Lake Champlain Transportation Co.

LAKE CHAMPLAIN TRANSPORTATION CO.
KING STREET DOCK
BURLINGTON, VT
802-864-9804
TICKETBOOTH ELEVATION DRAWINGS

From: Chris Burke <ChrisB@ferries.com>
Sent: Wednesday, February 24, 2016 12:21 PM
To: Ryan Morrison
Subject: RE: King Street - Burlington - Ticket Booth Replacement

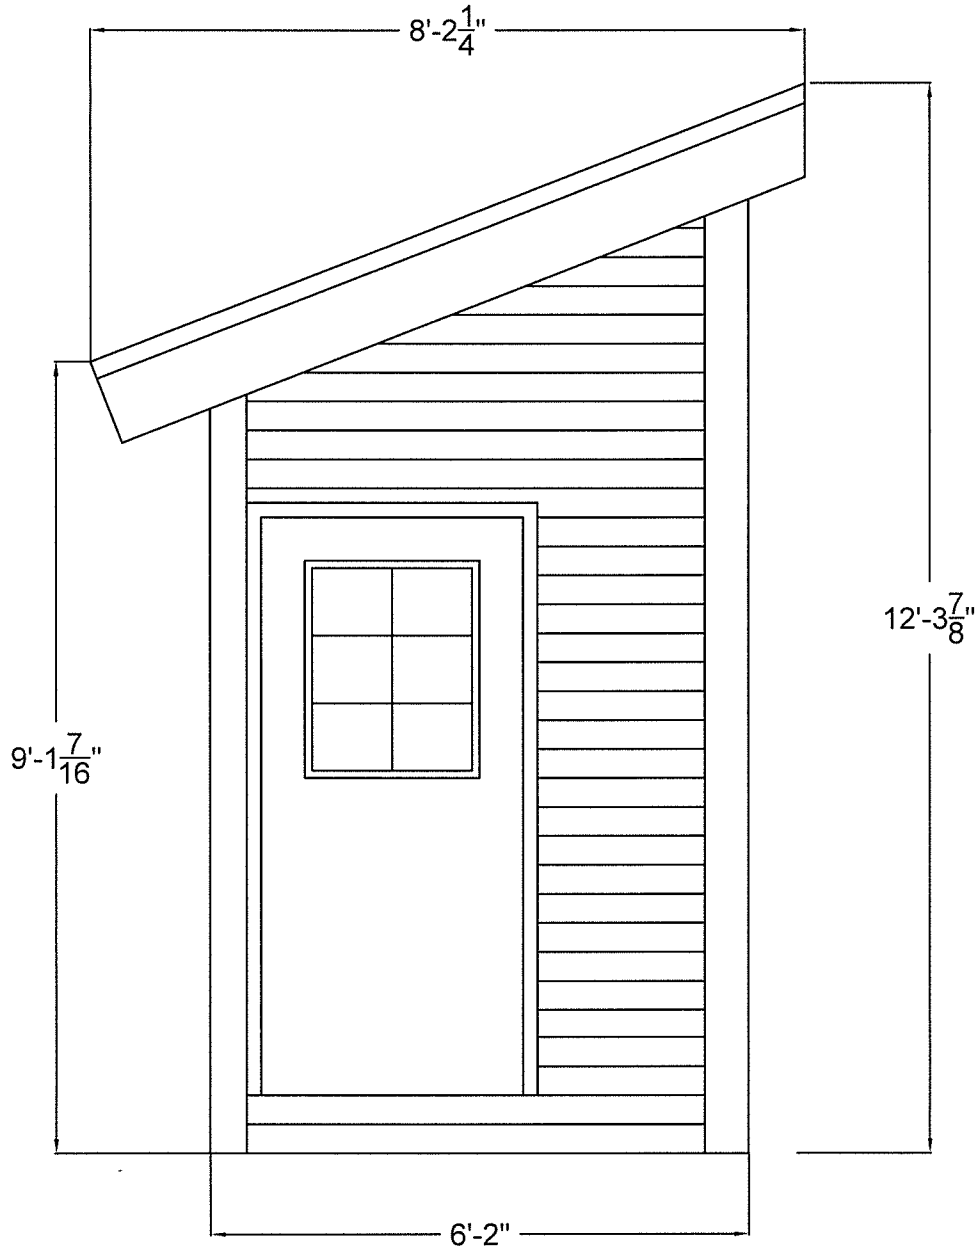
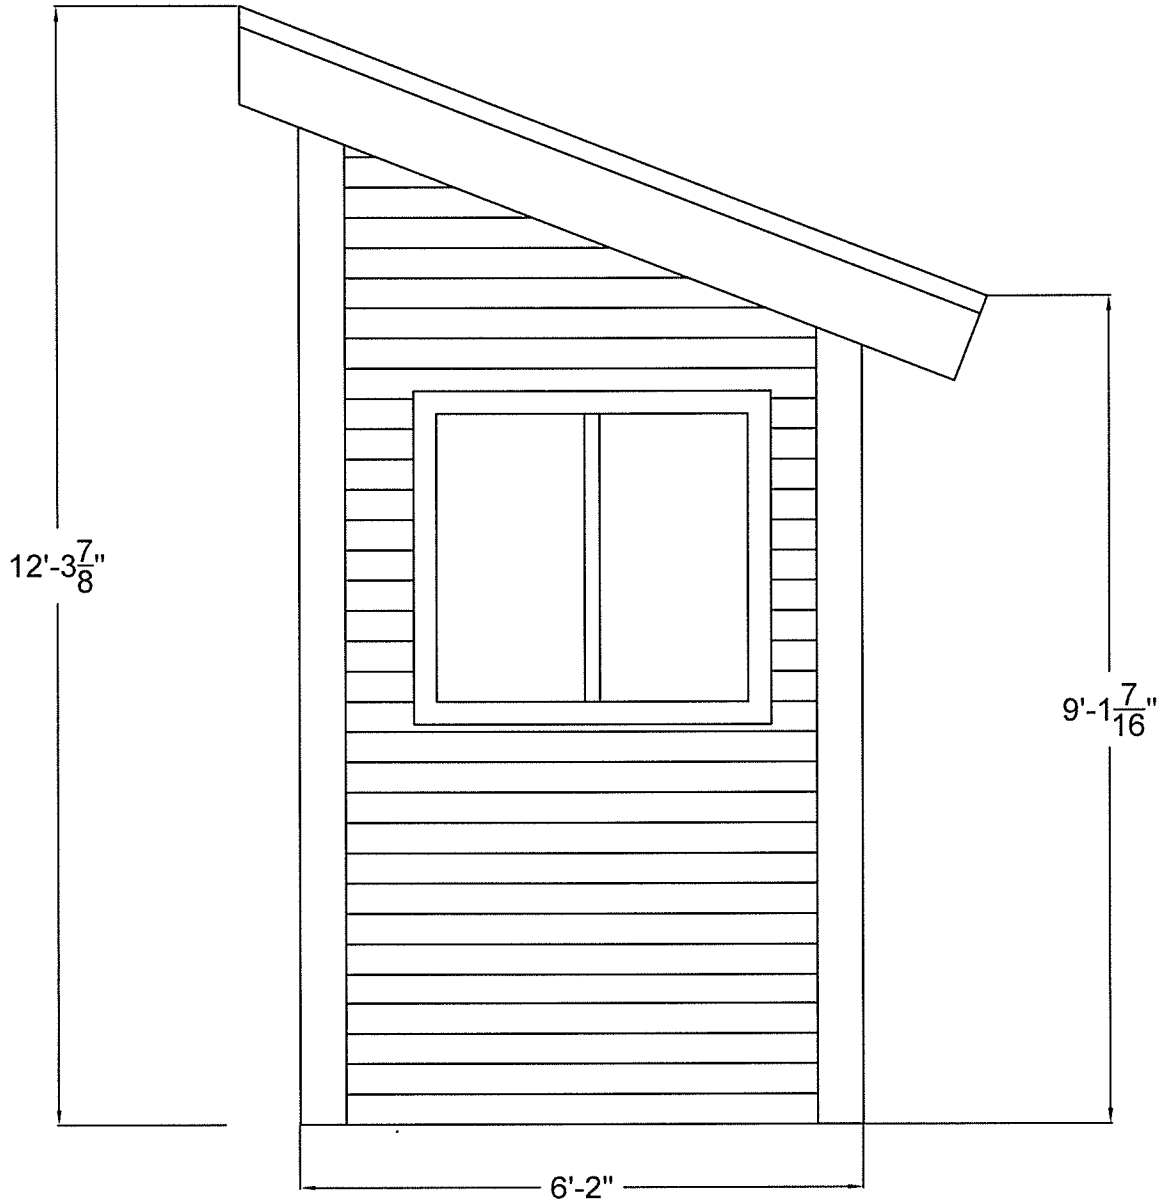
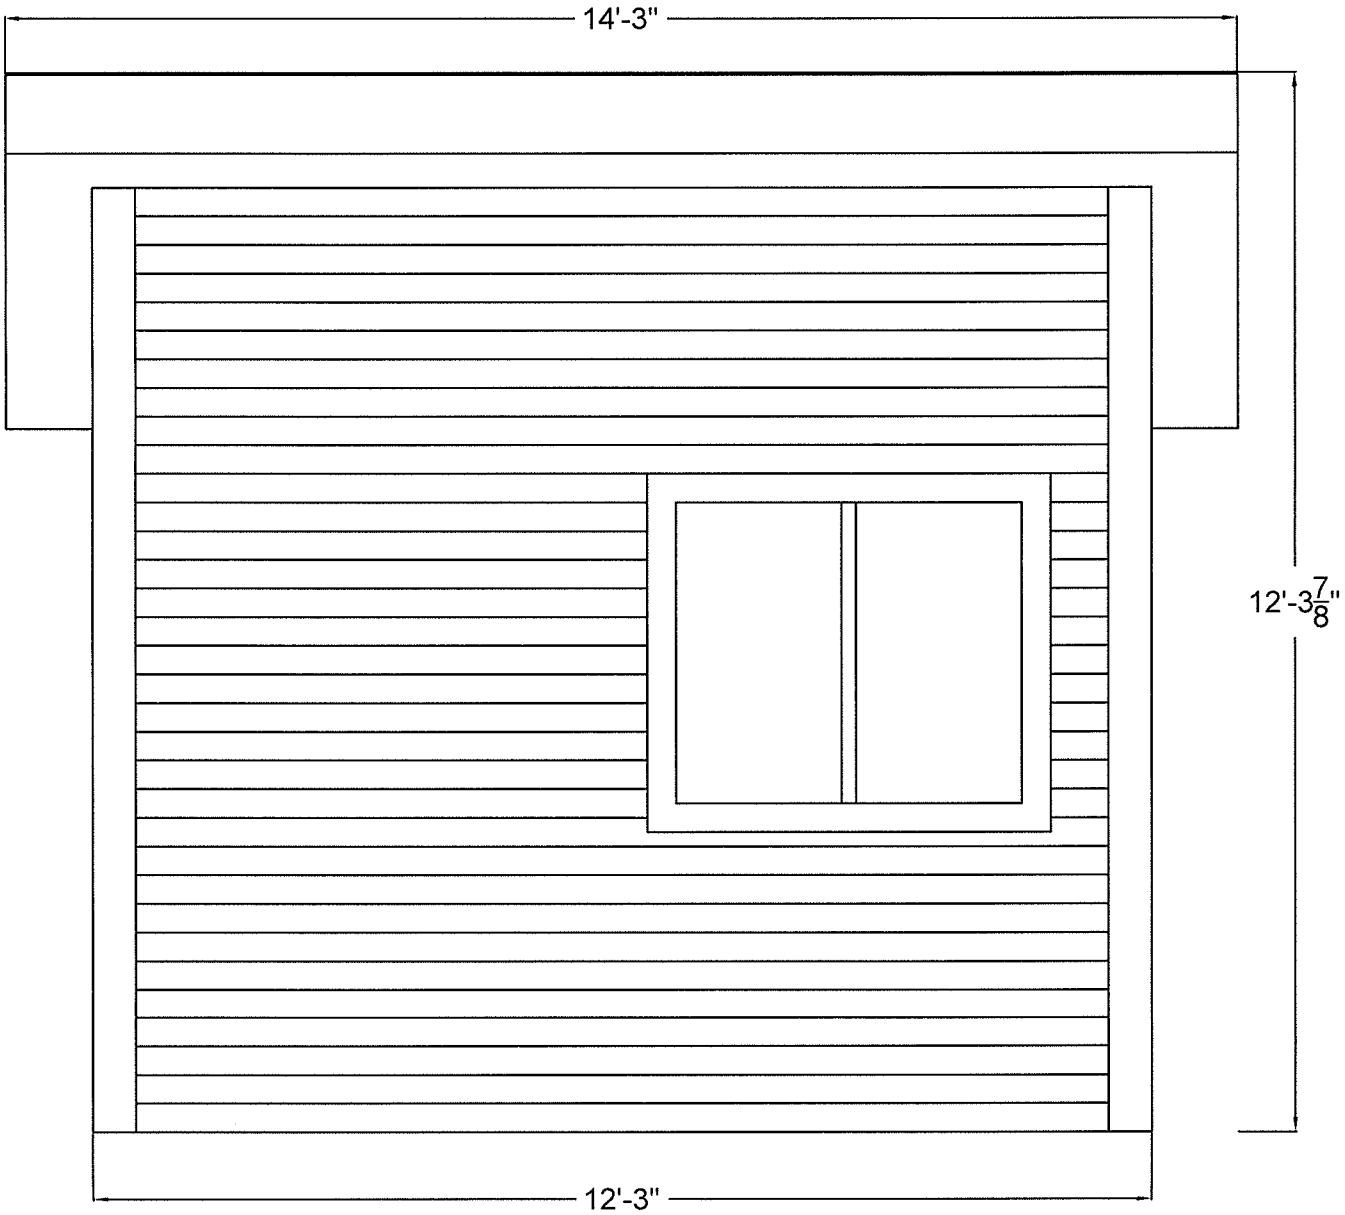
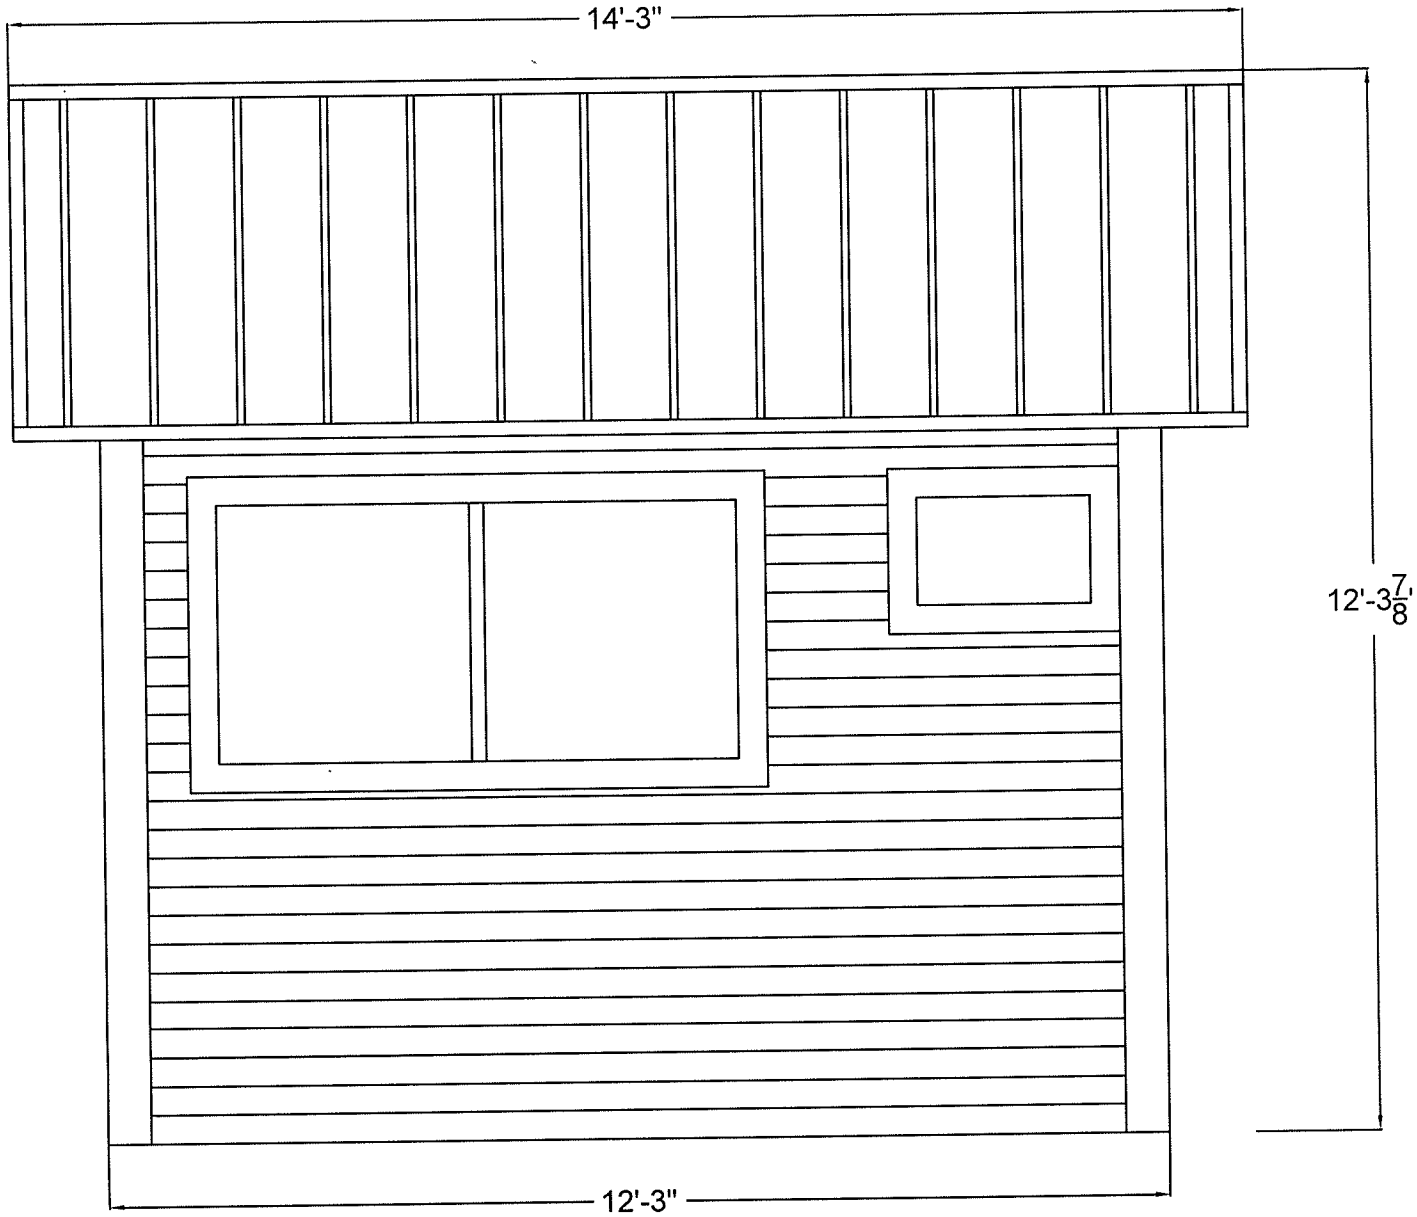
Also, what is the Ready Access manual for? Is a pass-thru window being proposed? Because I don't see one on the elevation drawings.

The Read Access window will be the window on the North of the building which will be used to actually sell tickets. It is window similar to one at any fast food drive through.
